ENGINEERING CHANGE NOTICE
DART AEROSPACE LTD

Date: 07.08.14	Job No.: 00056	ADR Yes/No: Yes	ADR Date: 07.08.14	ECN #: 1020
Product No.: D412-673		Created By: CB	Approved By: NW	
Product Name: Electric Step Kit		Checked By: EC		General Manager Approval:

AMENDMENT DESIGN REVIEW (ADR)Part/Installation No.: IIN-D412-673 Rev: B Design Review No.: _____ Date: 07.08.14Project Number: D412-673 Project Description/Title: Electric Step KitEng. Project Manager: Christopher Bell

ENGINEERING CHANGE NOTICE
DART AEROSPACE LTD

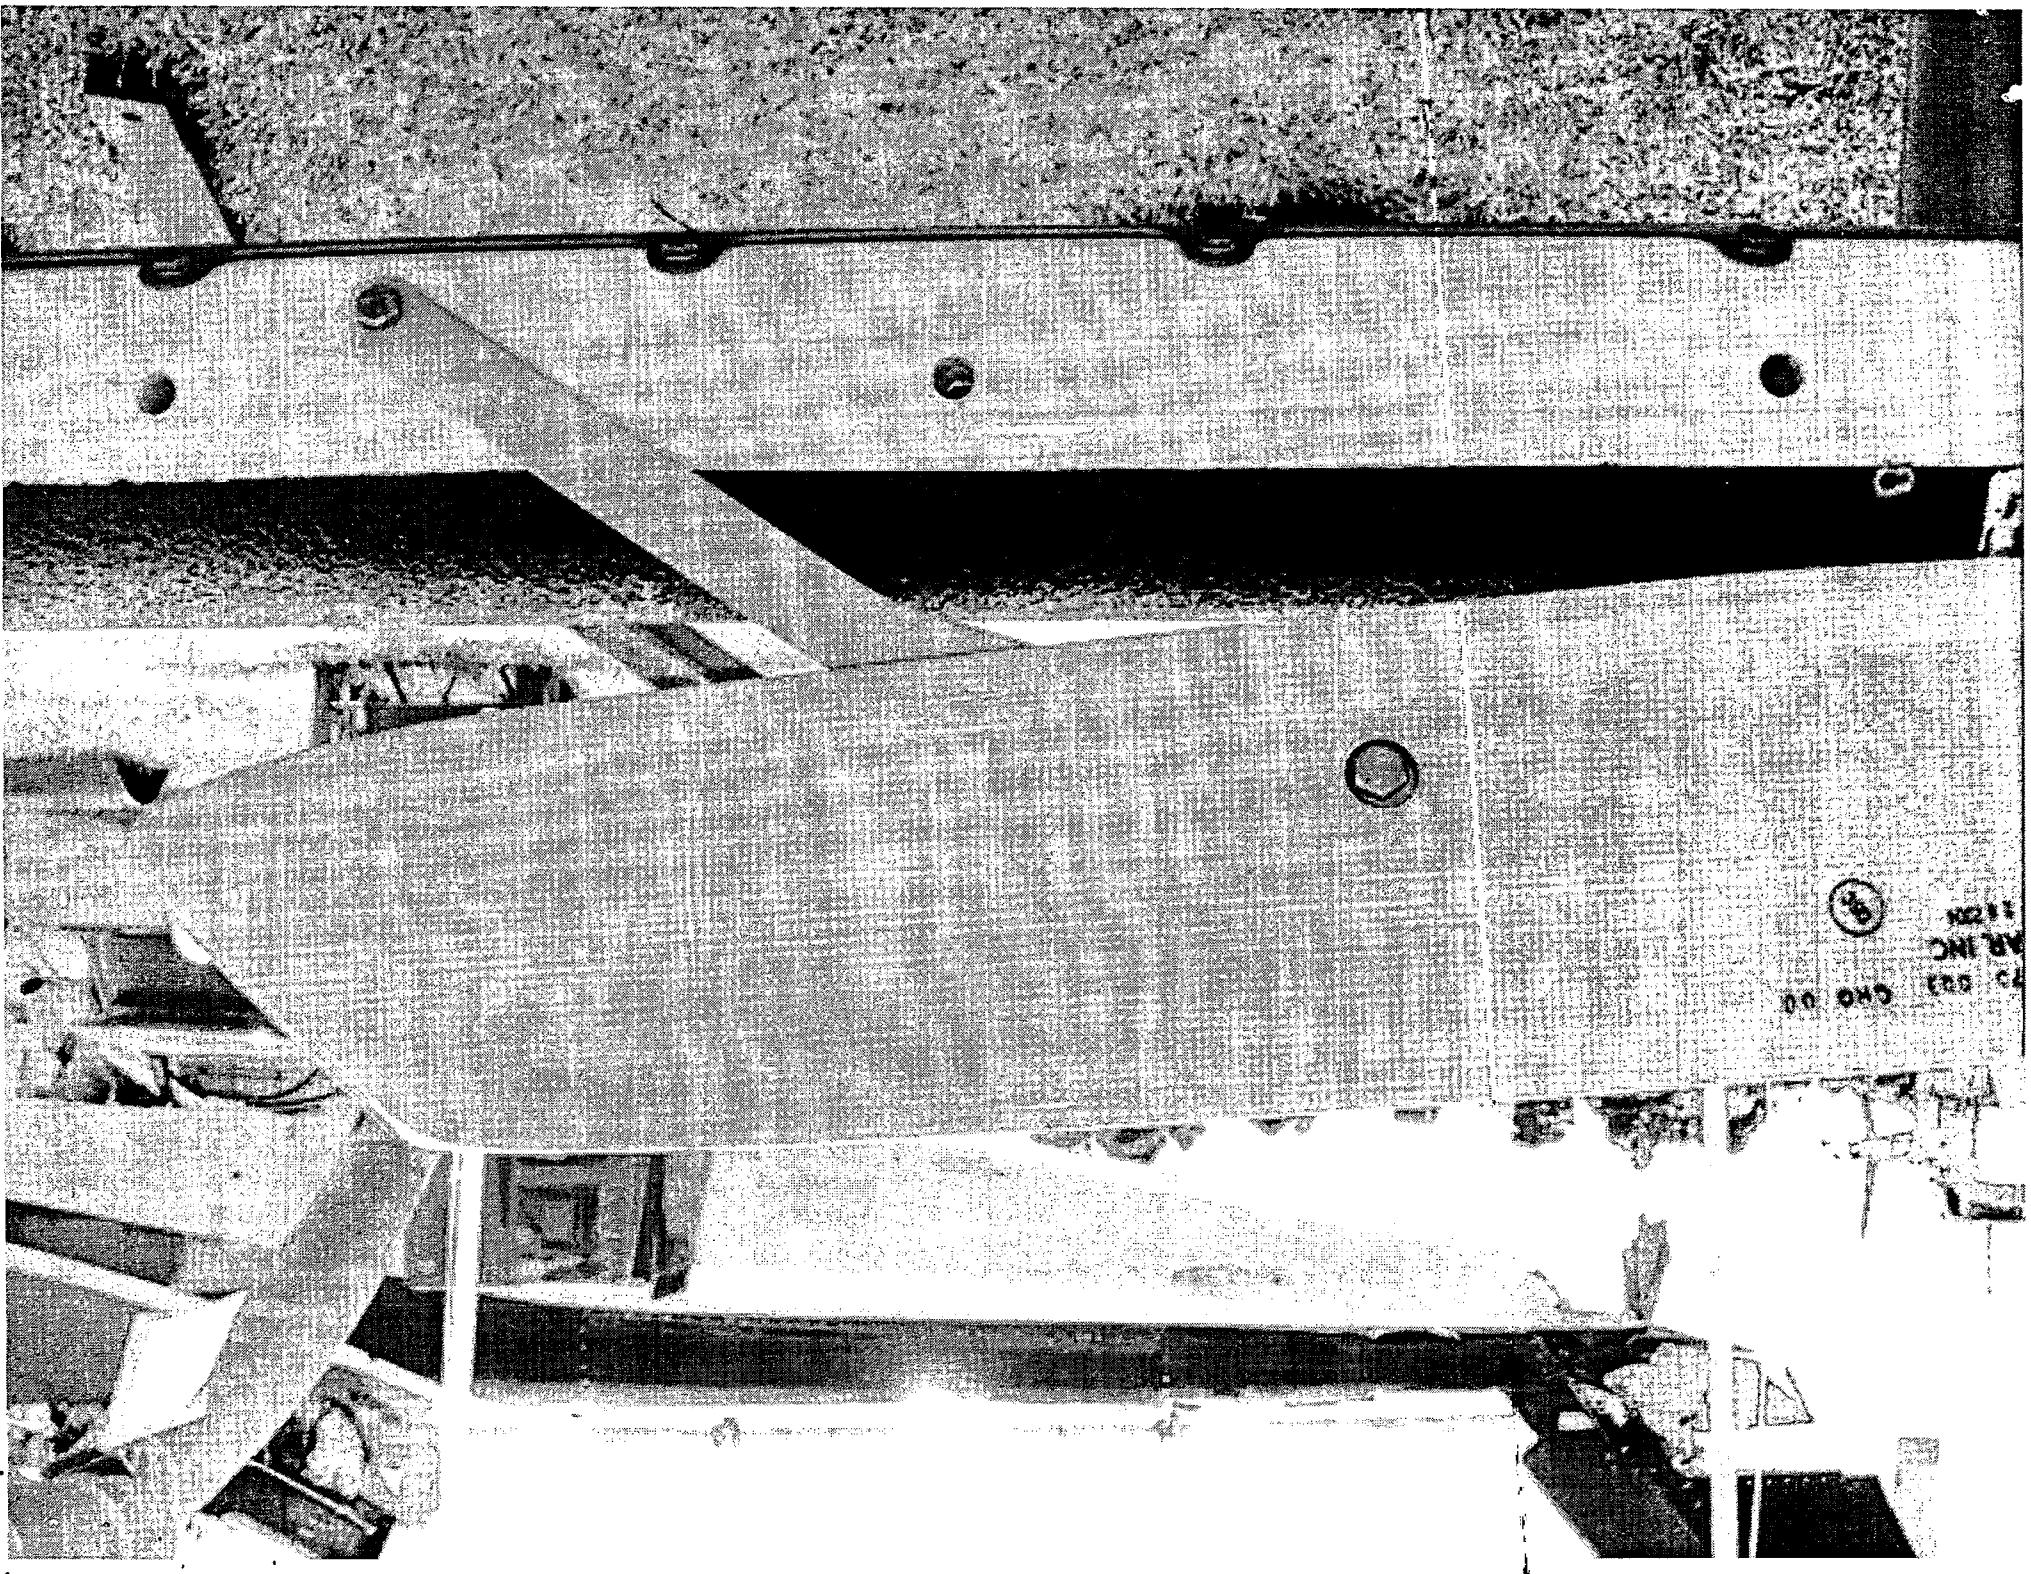
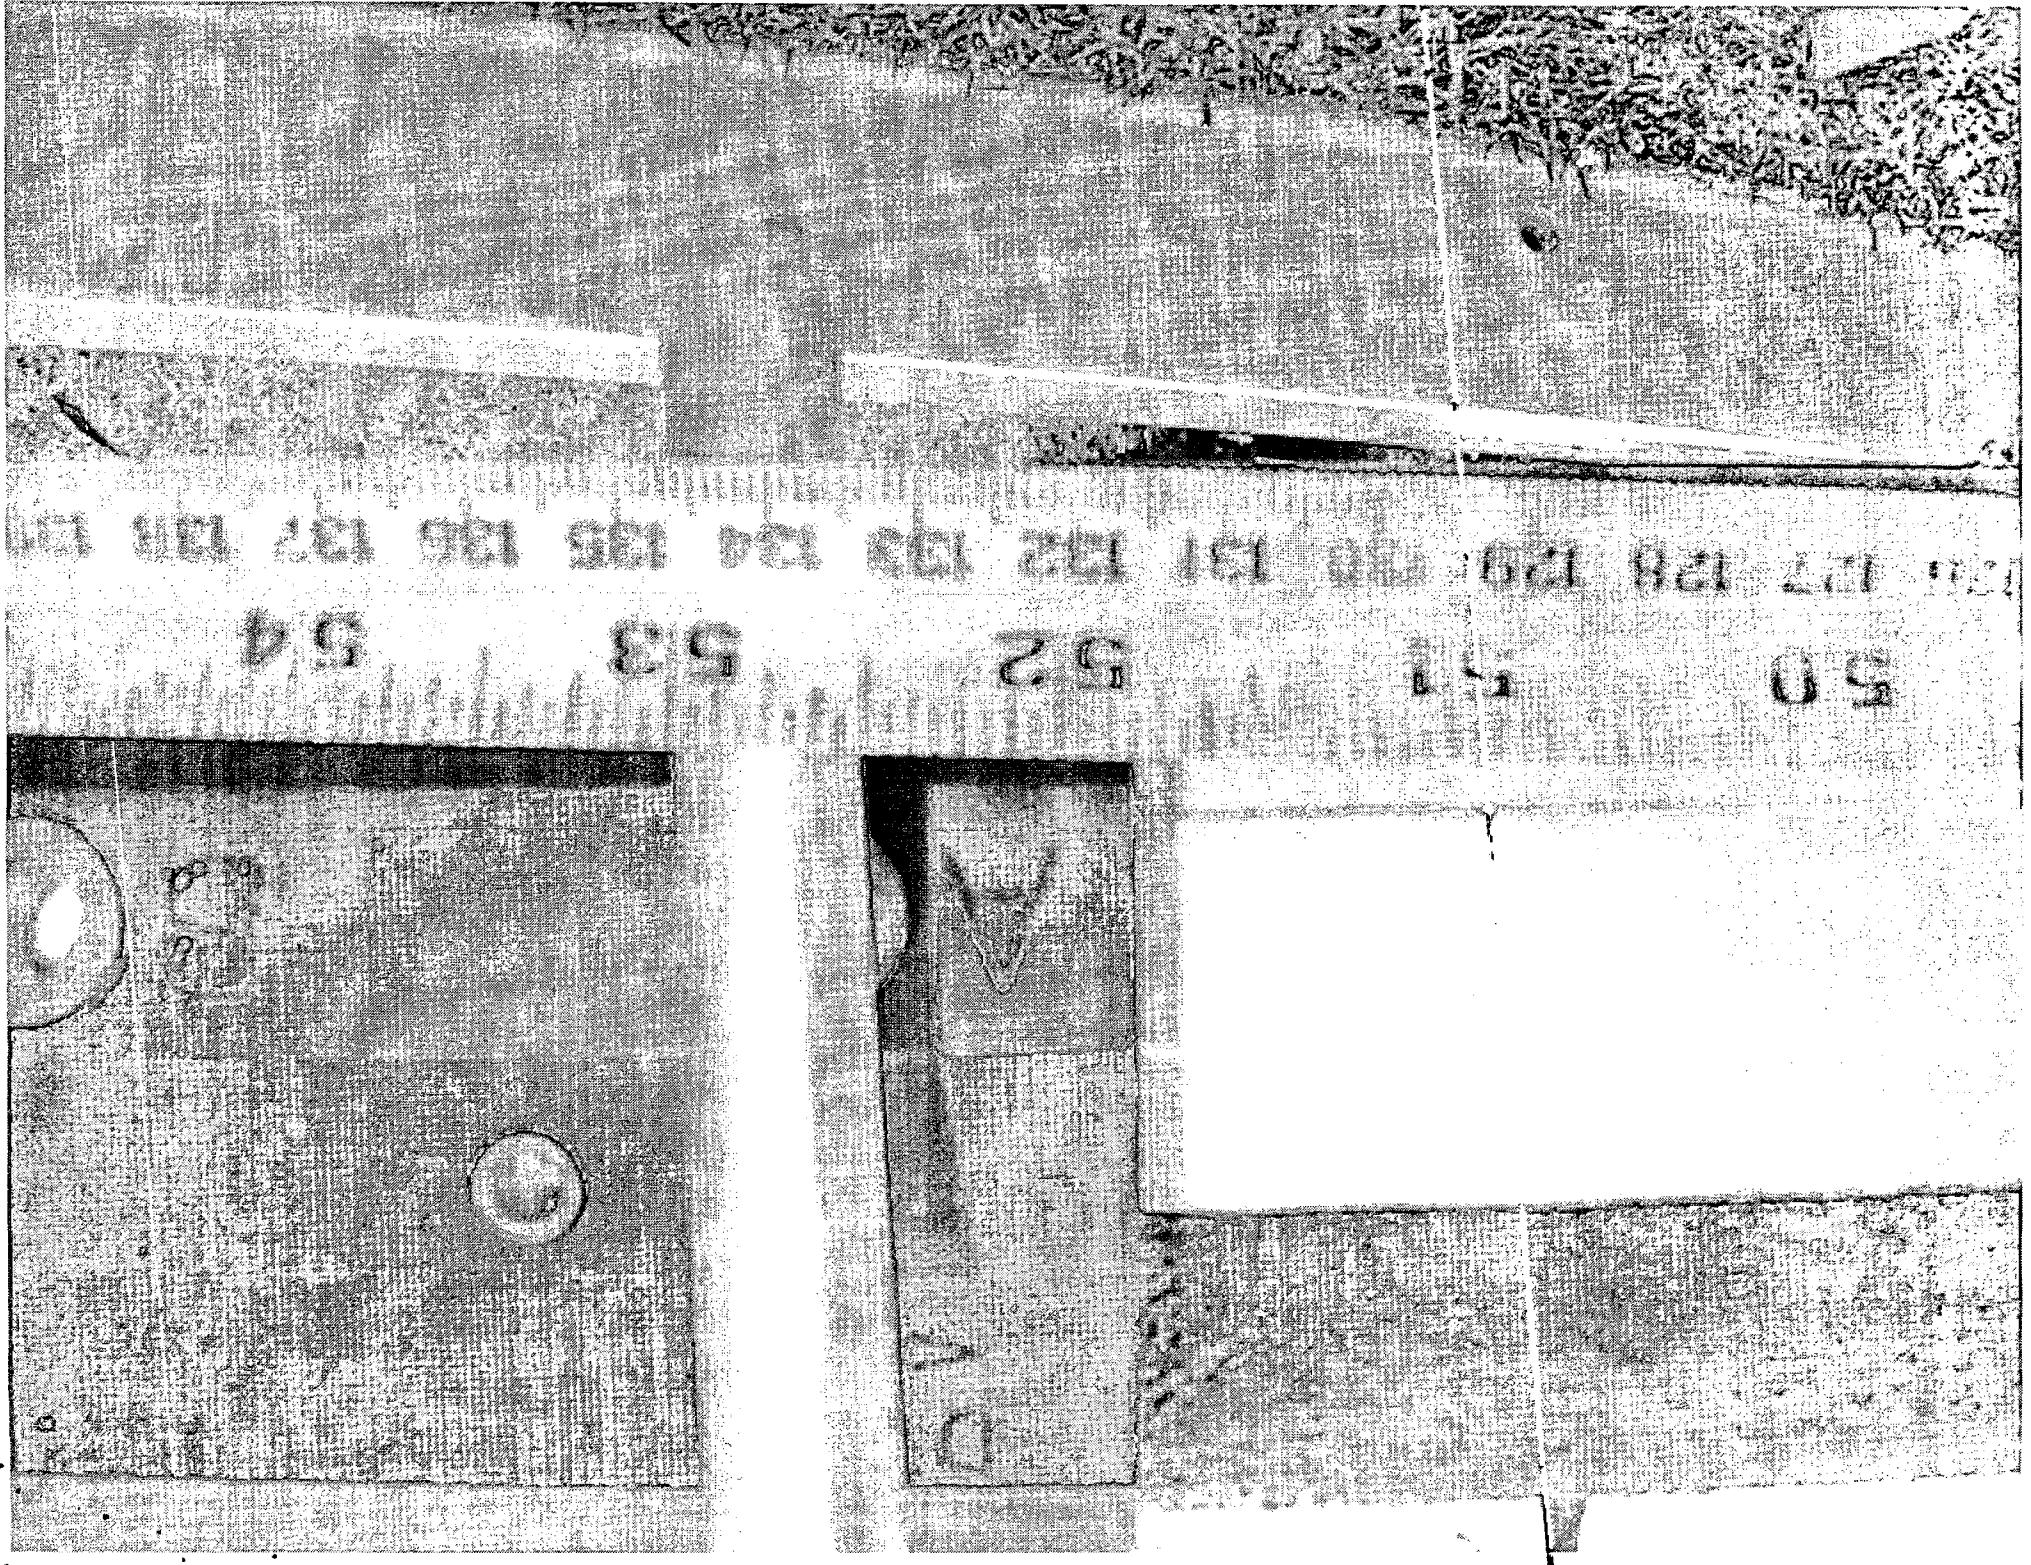
We are using the standard installation instructions for the left hand side as per table one. We have run into a problem where it seems that the rear attachment holes are located too far fwd by 1". Not allowing the step to sit level when the step is in the retracted position.

The instructions say to locate the jig at STA 128.3, insert pin A at STA 124.1 & pin D at STA 132.3 and drill holes #3 & #13 which we have carried out, leaving us with the problem as per photo 1.

Do we have the wrong Jig ? Pn DT 8393-1 & -2 Do we have the wrong Pn Step assy, Pn 212-030-470-003 as per Bell kit 212-706-105-003 or are the instructions incorrect for our Pn skid tubes ?

Can you please get Natalie T to send out four more inserts Pn ALS7-428-165 with approval to relocate the holes #3 & #13 aft by approximatley 1" ASAP .

2) The step in the installation instructions where the aft step arm holes are drilled has been modified so that the customer will test fit the step before drilling the holes to confirm that they do line up as expected. If they do not line up, a procedure is given for finding the correct locations.
